**MONTGOMERY COUNTY HISTORIC PRESERVATION COMMISSION**  
**STAFF REPORT**

<b>Address:</b>	7118 Cedar Ave., Takoma Park	<b>Meeting Date:</b>	9/17/2025
<b>Resource:</b>	Outstanding Resource <b>Takoma Park Historic District</b>	<b>Report Date:</b>	9/10/2025
<b>Applicant:</b>	Laura Welch Kayla Richardson (agent)	<b>Public Notice:</b>	9/3/2025
<b>Review:</b>	HAWP	<b>Tax Credit:</b>	n/a
<b>Permit No.:</b>	1126544	<b>Staff:</b>	Devon Murtha
<b>Proposal:</b>	Replacement of windows and a door

Figure 2: Plan view of the house showing the location of replacement windows and one door.

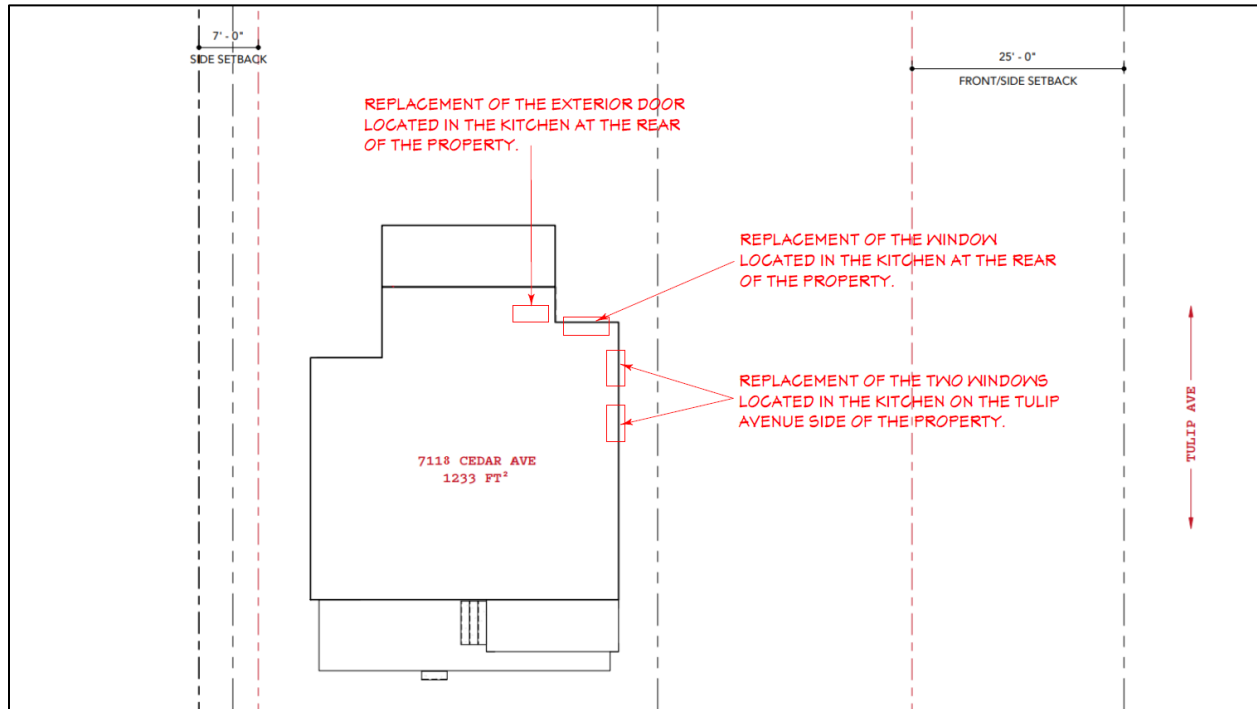
The applicant proposes to replace four (4) non-original double-hung wood windows on the right and rear elevation of the house with new Marvin Ultimate double hung wood windows. The applicant is also proposing to replace one (1) rear wood door with a new wood door.

Figure 3: Existing windows (left) and proposed new windows (right).

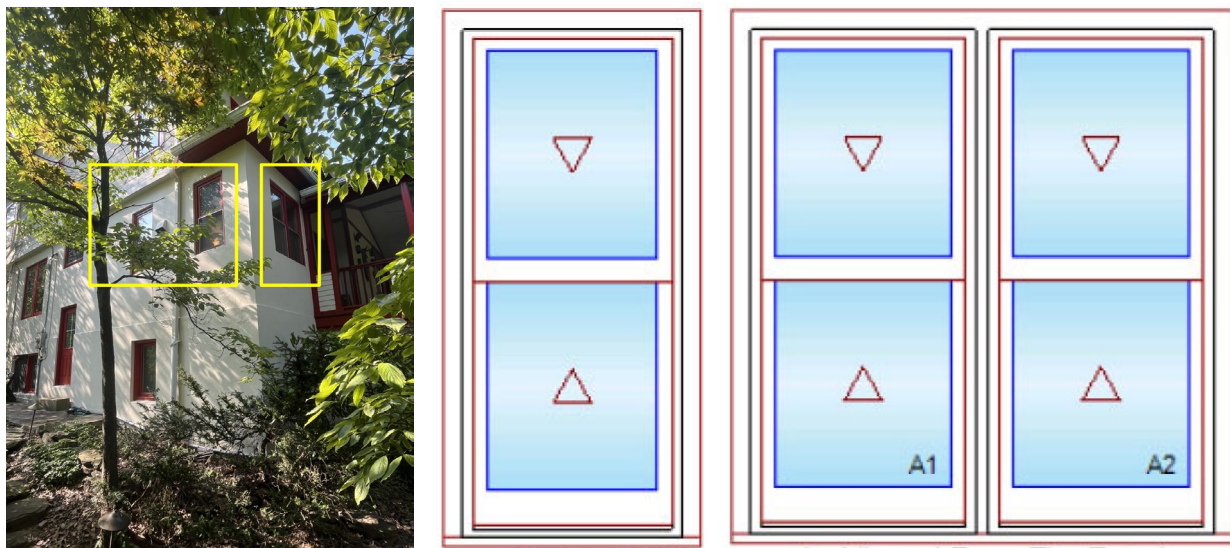
The applicant is proposing to remove four (4) double-hung wood windows from the right and rear elevations of the property and replace them with Marvin Ultimate double-hung wood windows with a similar profile (Figure 3). The new windows will be installed in the existing window openings.

The applicant is proposing to remove four (4) double-hung wood windows from the right and rear elevations of the property. Staff finds that the existing windows are not historic. The applicant submitted interior photos of the windows proposed for removal, as well as photos of the historic wood windows on the facade of the house (*Figure 6*). A comparison of these photos shows that the windows proposed for removal are distinct from the historic windows and likely date to a later renovation.
